August 16, 2016

Revised August 18, 2016

RE: Arlington Ale House, 100 W. Campbell, Third Floor, Staff Comments Round #1

Proposed Modifications - EGRESS

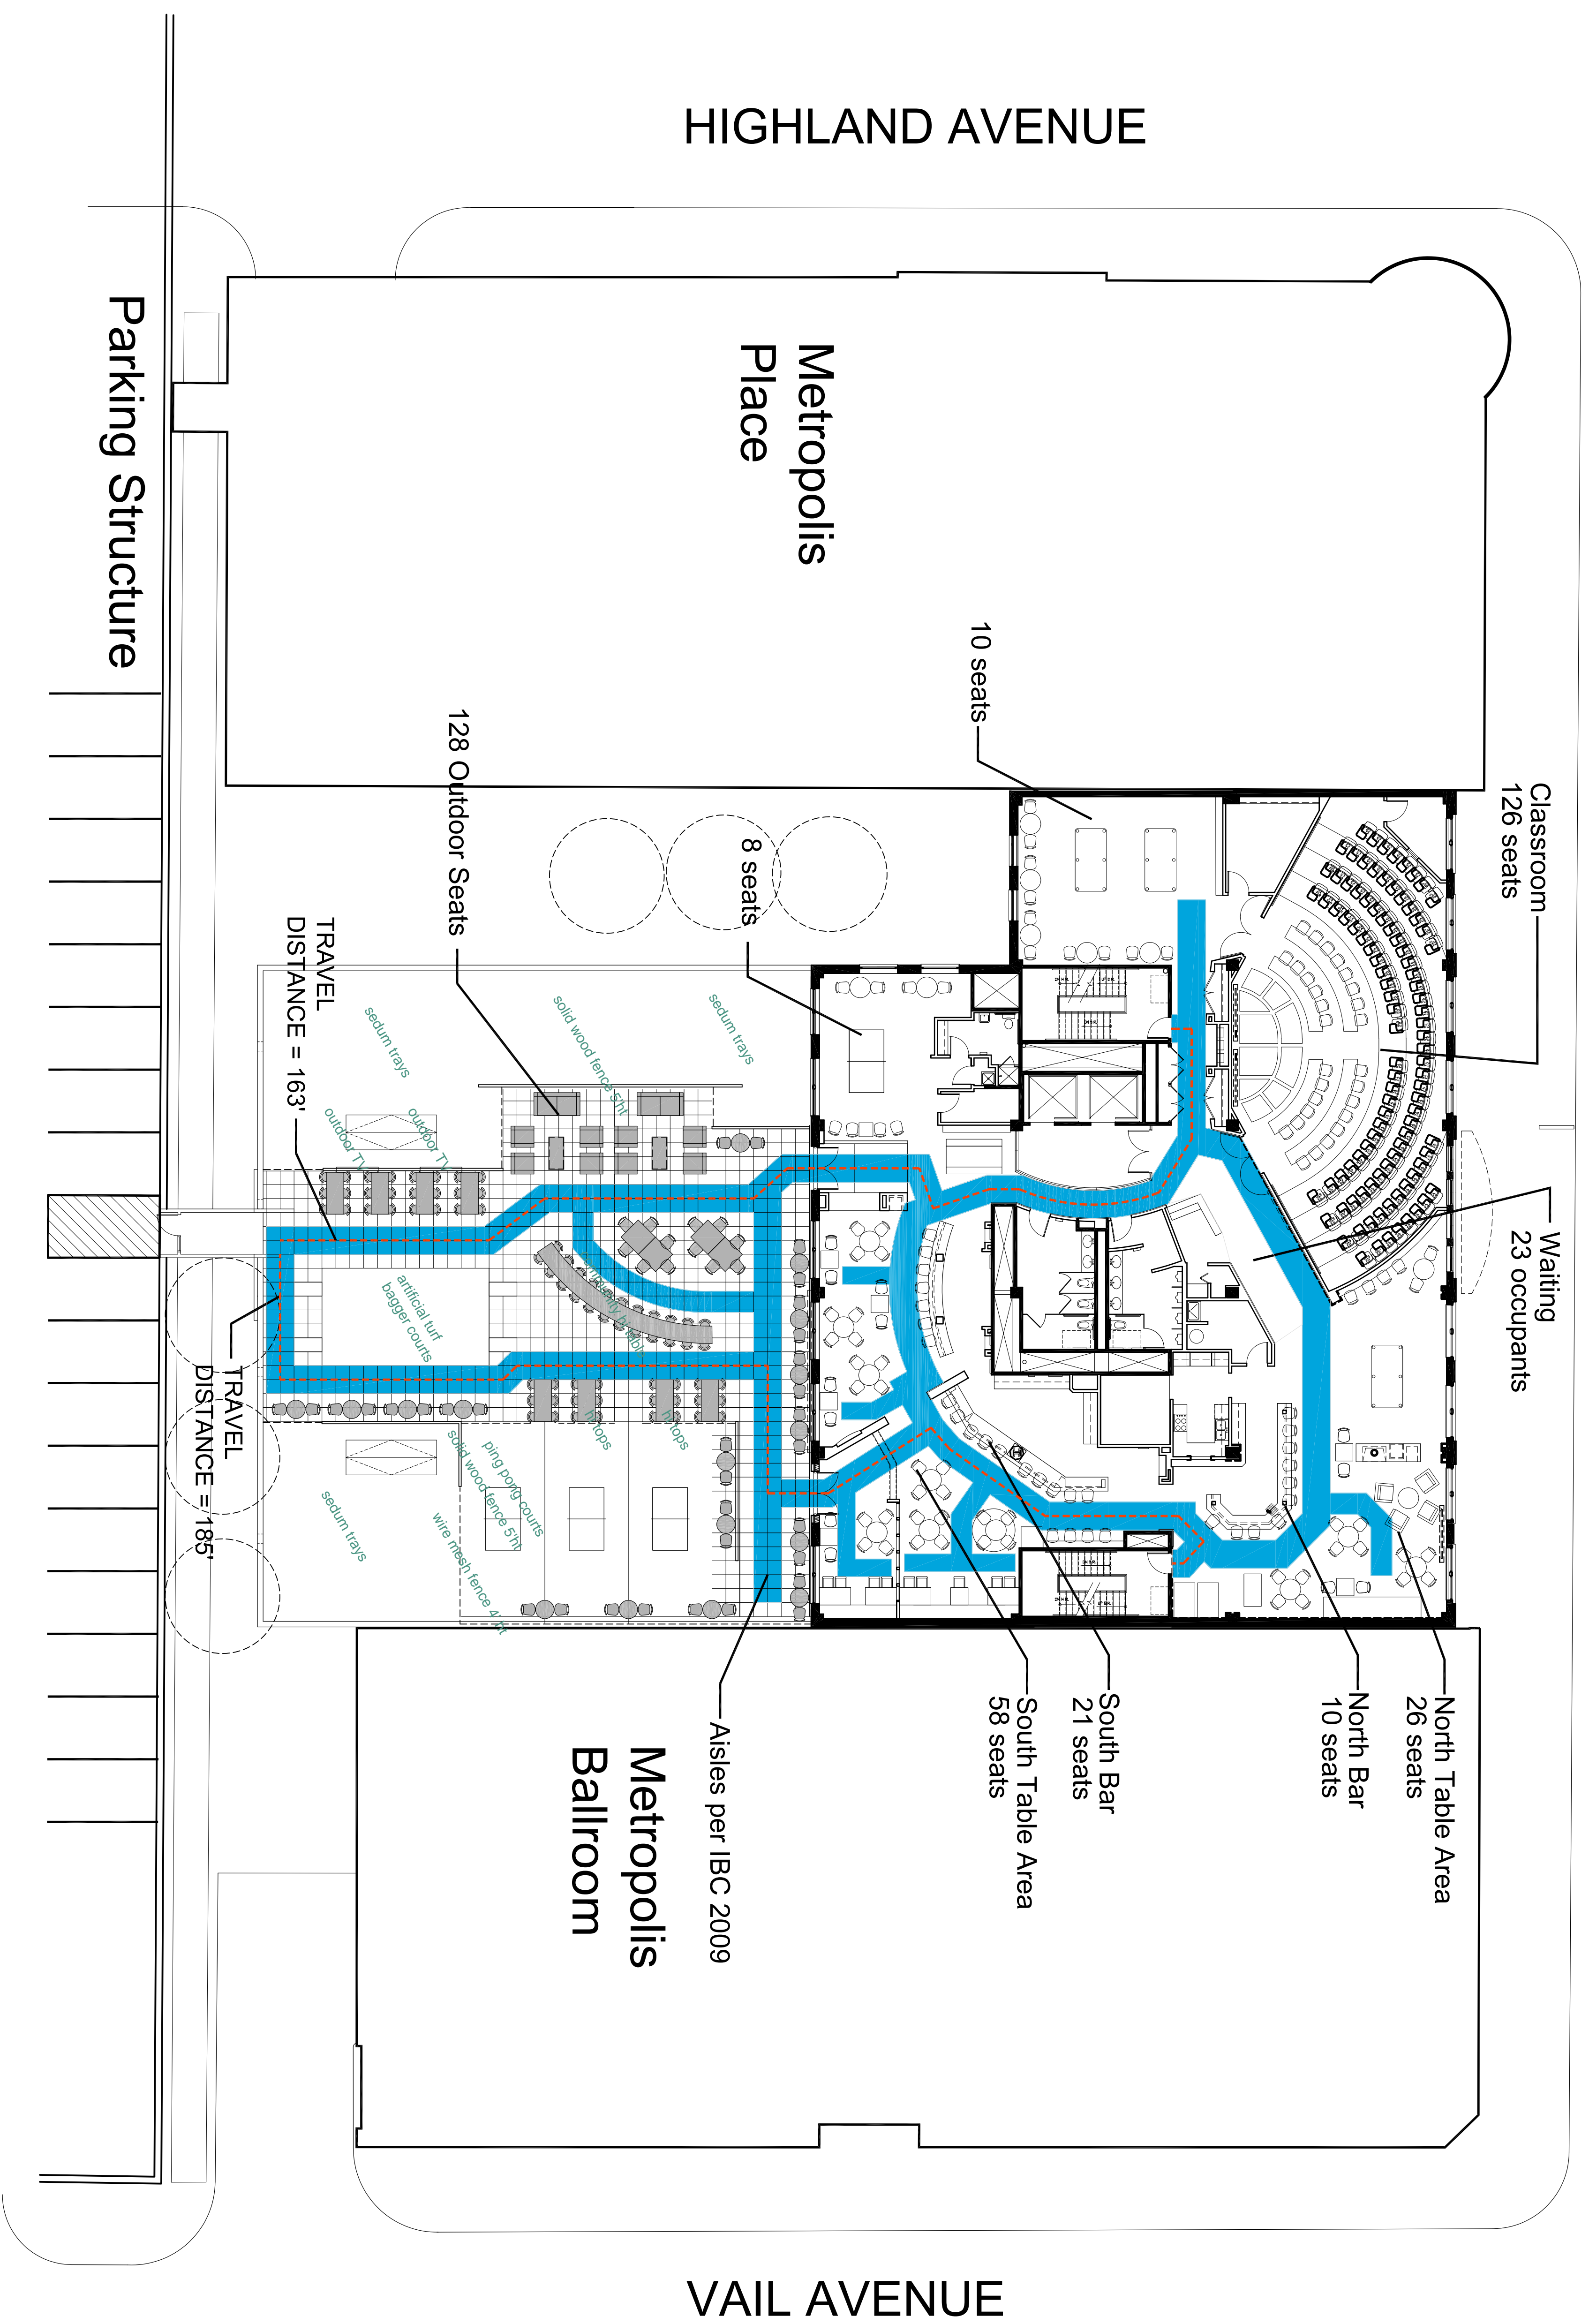
1. Agree. See egress diagram attached.

2. We believe we comply with separation distance requirements for the outdoor deck without considering the proposed "bridge". See Compliance with egress provisions of IBC 2009 above.
3. Agree.
4. Agree.
5. See attached diagram regarding travel distance to exits.
6. Agree.
7. Agree.

Although the building was designed under a previous code, HKM finds no non-compliant egress requirement for the current or proposed space configuration under the current code. The proposed bridge to the parking deck was not considered. For this exercise HKM limited its egress analysis to these items:

- Number of exits
- Stair width (limits occupancy per above)
- Common path of travel
- Dead end
- Main exit required
- Aisle widths at tables and chairs (see diagram)
- Travel distance (see diagram)
- Separation of exits*

TRAVEL
DISTANCE = 163'

TRAVEL
DISTANCE = 185'
